## Staff Report to the Zoning Administrator

Application Number: **07-0117**

Project Description: Proposal to demolish an existing single-family residence on two lots (043-161-57 and -58) and construct one single-family residence of about 5,000 square feet with an attached garage on parcel 043-161-58. Requires a Coastal Development Permit and an Engineering Geologic and Soils Report review.

Location: Project located at the southern end of Bayview Drive, on the site of 660 Bayview Drive.

Trousdale residence  
660 Bayview Drive, Lot B, Aptos  
View from Via Gaviota seawall  
Matson Britton Architects  
Rendering: ArchiGraphics

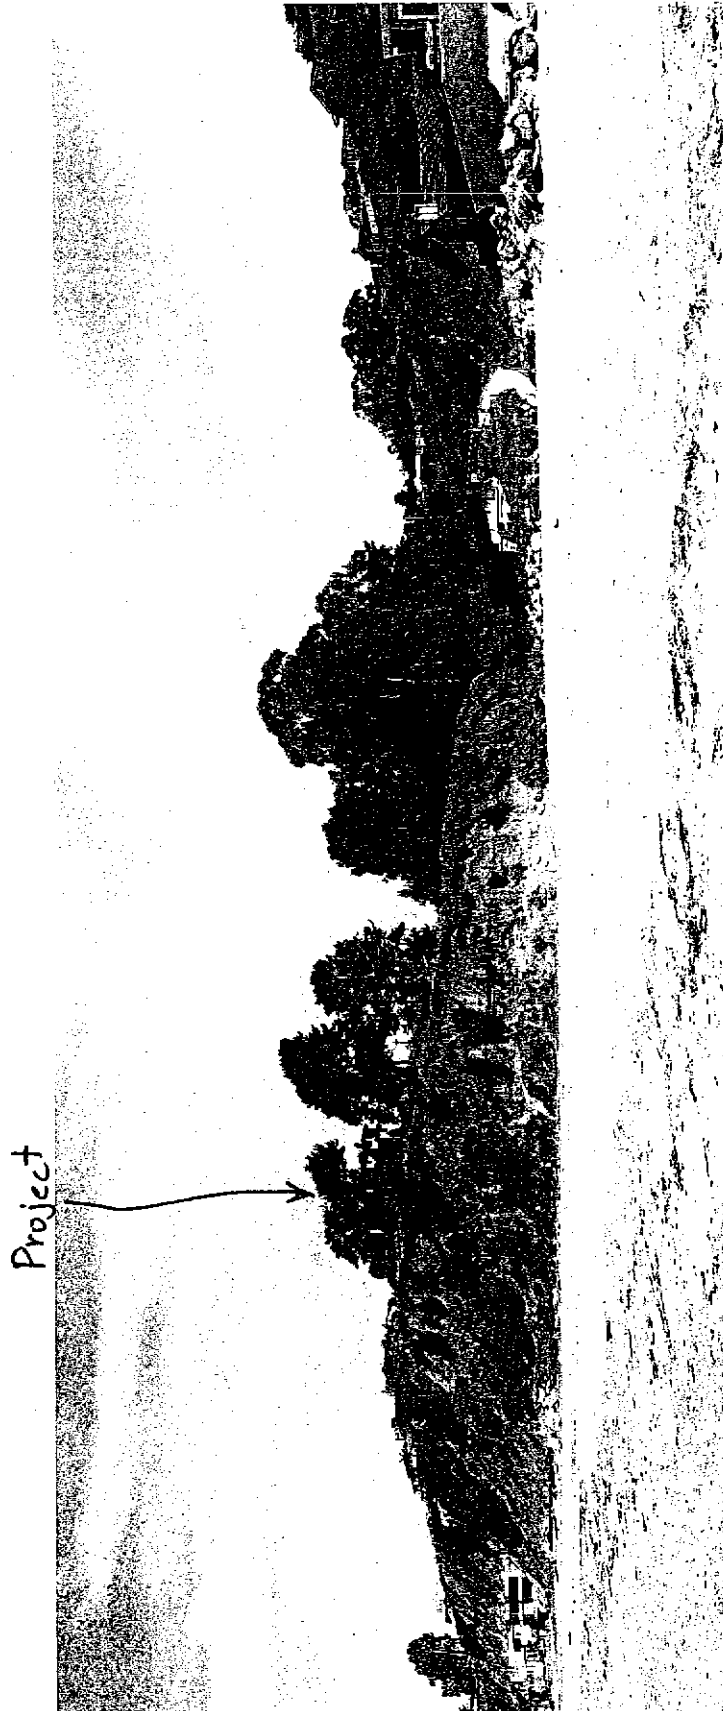
*This is an unusual site, given the turn around and island in the right-of-way and the downslope of the grade from Bayview Drive. If this residence were proposed for a lot in the middle of Bayview on the bluff side, it would seem too large for the same size lot.*

*The designer should be aware that a design for the remaining lot to the West, it may not be compatible with neighborhood to build with the full 50% FAR (it is far more visible than the current proposal).*
